# Access Compliance Report

## Public Rights-of-Way

| Intersection ID: 5674 | Main Street: HAMILTON_CR | Cross Street: JOHOY_DR  | Location: NW           |
| ADA ID: 0D0567EE2929  | Ramp Type: Perp          | Initial Pass/Fail: Fail | Overall Compliance: No |

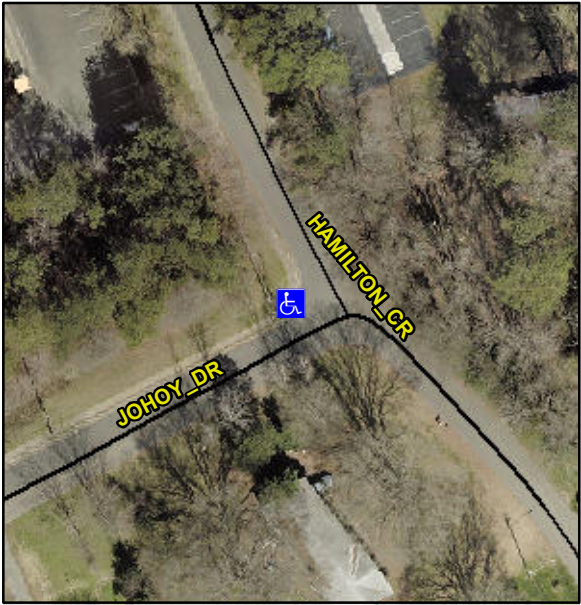
| Codes/Mitigation Info/Possible Solution                                                               |                                          |  | Field Measurements/Component Compliance |                             |             |
|-------------------------------------------------------------------------------------------------------|------------------------------------------|--|-----------------------------------------|-----------------------------|-------------|
|                                                                                                       | <b>Remove &amp; Replace Entire Ramp.</b> |  | <b>No</b>                               | Ramp Length (in)            | <b>60.0</b> |
| <p>Surveyor Notes:</p> <p><b>N/A</b></p> <p>PROW/ADA:</p> <p><b>Not Found, R304.2.2, R304.5.3</b></p> |                                          |  | <b>N/A</b>                              | Flare Type RT               | <b>N/A</b>  |

| Codes/Mitigation Info/Possible Solution                                                               |                                          |  | Field Measurements/Component Compliance |                             |             |
|-------------------------------------------------------------------------------------------------------|------------------------------------------|--|-----------------------------------------|-----------------------------|-------------|
| <p>Total Cost:</p> <p><b>\$ 1850.00</b></p>                                                           |                                          |  | <b>No</b>                               | Painted X Walk2?            | <b>N/A</b>  |
